**SERVICE**

## **TECHNICAL BULLETIN**

Delayed Engagement –  
Powertrain 4L80-E Transmission –  
Revised Specification Transmission

MODEL 1996 MY  
XJ12 Sedan  
VIN  
754304-782045

ILLUSTRATION 1

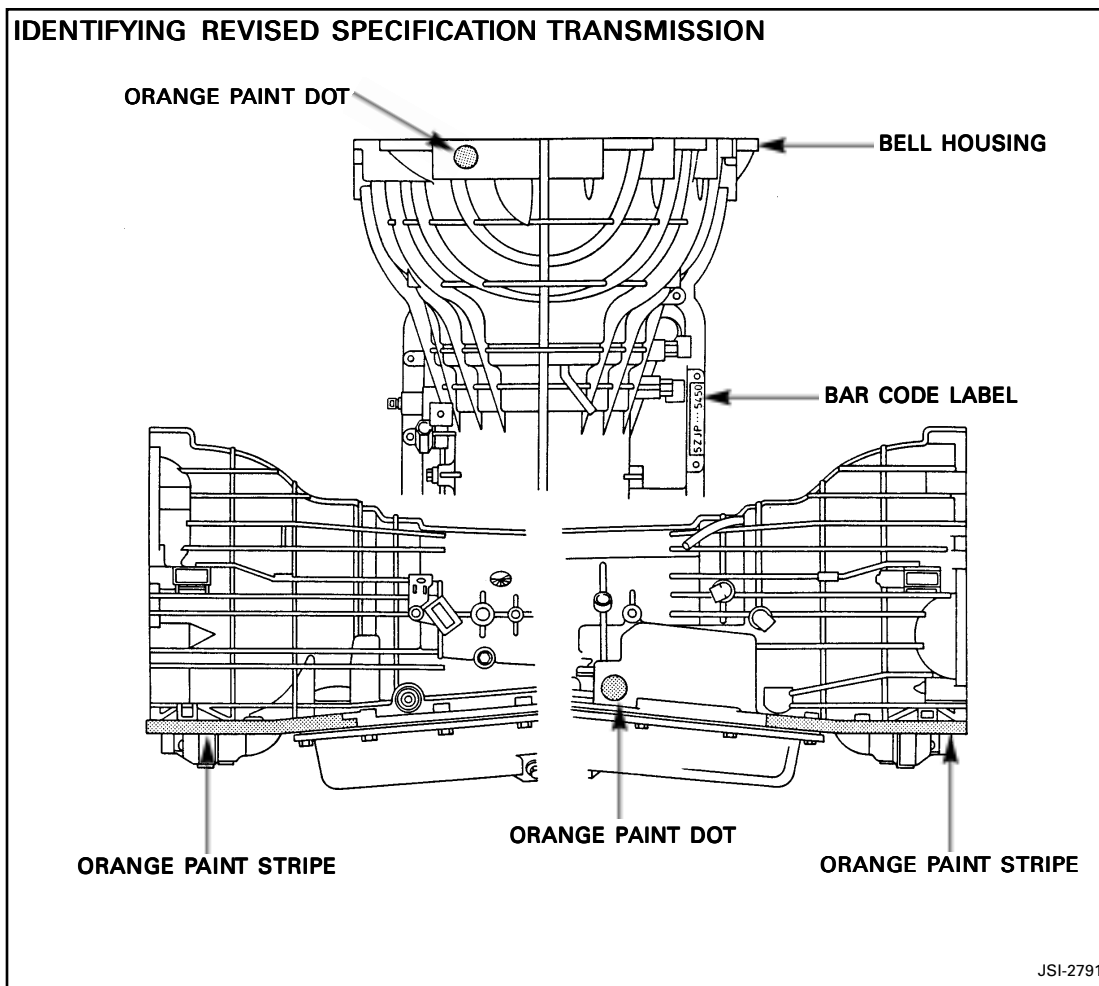
Transmissions with a serial number after 95ZJP5450 are the revised specification. Some transmissions with a lower serial number are the revised specification only if they are marked as shown in Illustration 1 on the following page.

Transmissions with serial no. before 95ZJP5450 with the following identification marks (Illustration 1):

- Orange paint dot, applied to the bell housing top, (not visible with transmission installed in vehicle).
- Bar code label on upper face of transmission case flange (visible by using mirror, with transmission installed in vehicle).
- Orange paint stripe at right side of the bell housing (on the continuation of the case flange).
- Orange paint dot, applied to the name plate surface on the right side of the transmission case.
- Orange paint stripe at left side of the bell housing (on the continuation of the case flange).
